ITEM #1: ARCHITECTURAL COMMISSION; March 15, 2021 @ 7:00 P.M.

REQUEST: Consideration of a request for replacement signage for “Coldwell Banker” “Building A”; 4192 Route 83; within the Sunset Grove Development, submitted by Neon Prism Electric Sign Co, Inc.

RETAIL 'A' WEST ELEVATION

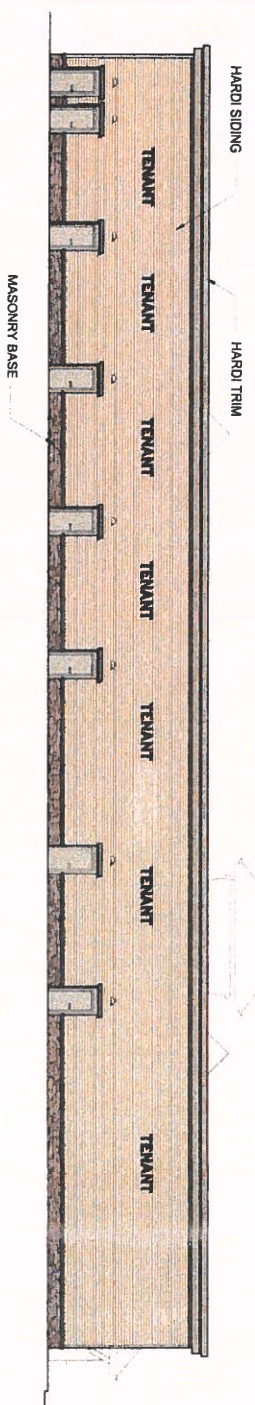
A copy of the approved elevation for “Building A” is attached. As signage relates to this portion of building, the “Coldwell Banker” signage, as proposed, is in the "Designated Zone for Placement of Signage and Graphics" as indicated on the approved PUD plans.

Petitioner is again proposing one wall sign on the west facade of "Building A" over the building entrance and in the location approved as the "Designated Zone for Placement of Signage and Graphics". This is consistent with the final PUD approval.

The proposed signage is on the west elevation and is within the allowable square footage for such signage per the PUD approval ordinance.

** PROPOSED SIGN LOCATION*

The signage as proposed is consistent in both size and placement with the final PUD approval. The sign is therefore approvable as submitted.
